102-08295 – CS/LH  
July 22, 2021

Subject: **Palo Verde Nuclear Generation Station (PVNGS)  
Units 1, 2, and 3 and Independent Spent Fuel Storage Installation  
Docket Nos. 50-528, 50-529, 50-530 and 72-44  
License Nos. NPF-41, NPF-51 and NPF-74  
PVNGS Emergency Plan, Revision 71**

## Revision 71

## Description of Changes

**FIGURE 1 ON SHIFT PALO VERDE EMERGENCY RESPONSE ORGANIZATION**

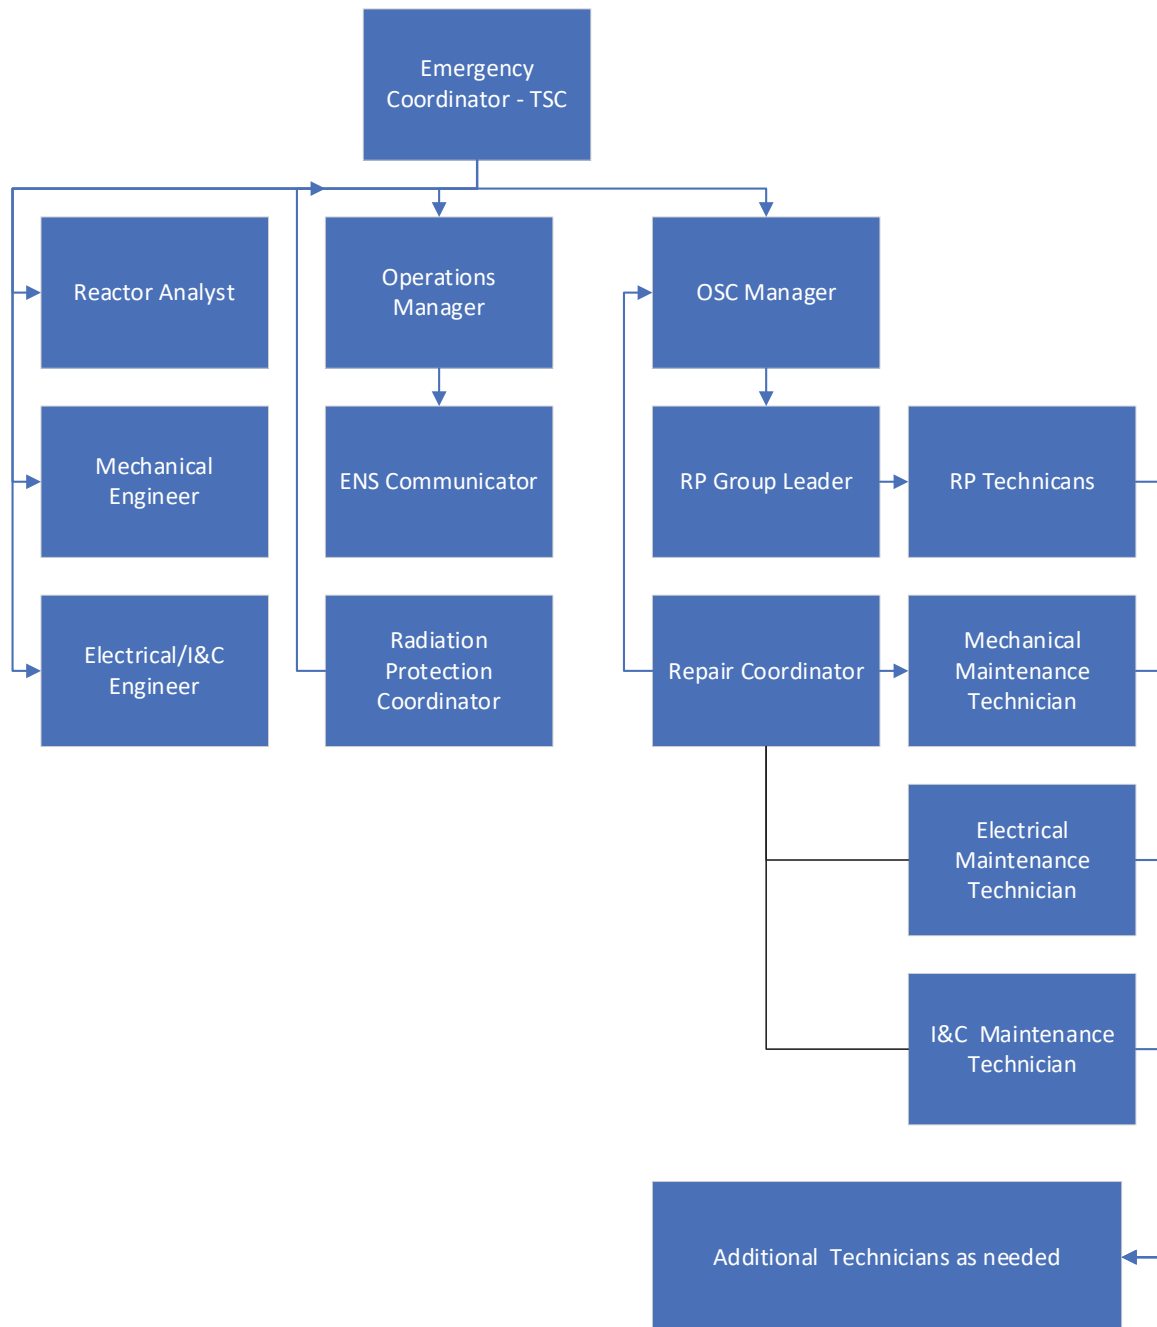
4.2.1.4, Table 1 and Figure 1	Changed Plant Equipment Operators to Auxiliary Operators
Table 1	Corrected footnotes to match LAR.
4.3.2	Updated Contract Support to allow for onsite contractors.

**FIGURE 6 NOTIFICATION ALERT NETWORK (NAN)**

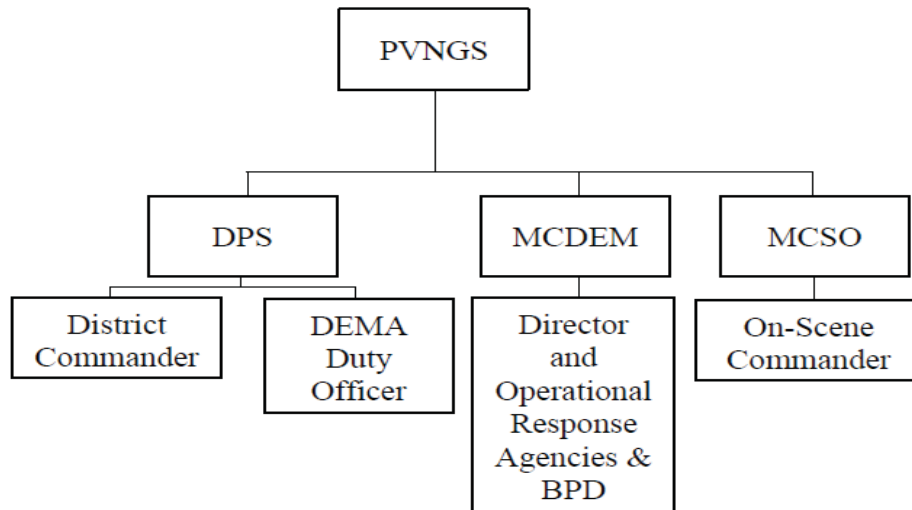
4.4.1.2	Deleted ADEM based on State reorganization.
4.4.1.3	Deleted AZDHS based on State reorganization
4.4.1.4	Changed ADEM to DEMA and added wording to show that DPS receives initial notification and provides information to DEMA
Figure 6	Updated figure based on State request

**NORMAL WORKING HOURS****OFF-DUTY HOURS****FIGURE 7 NAN NOTIFICATION FLOW**

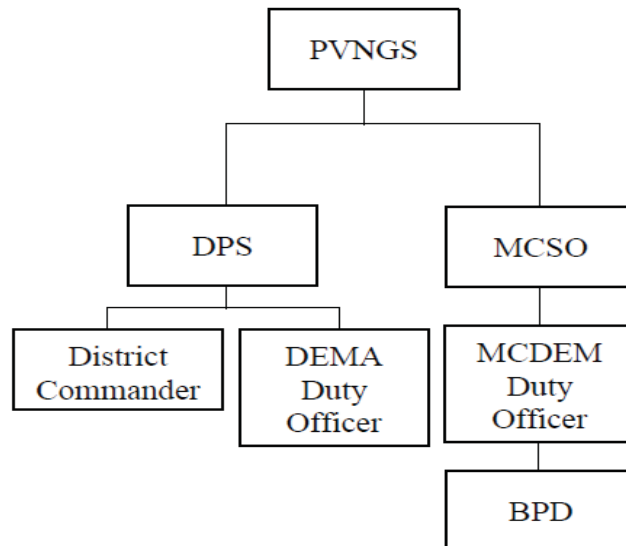
6.5.2	Replaced AZDHS with DEMA based on state reorganization
6.7	Replaced AZDHS with DEMA based on state reorganization
Figure 7	Updated NAN locations based on State request
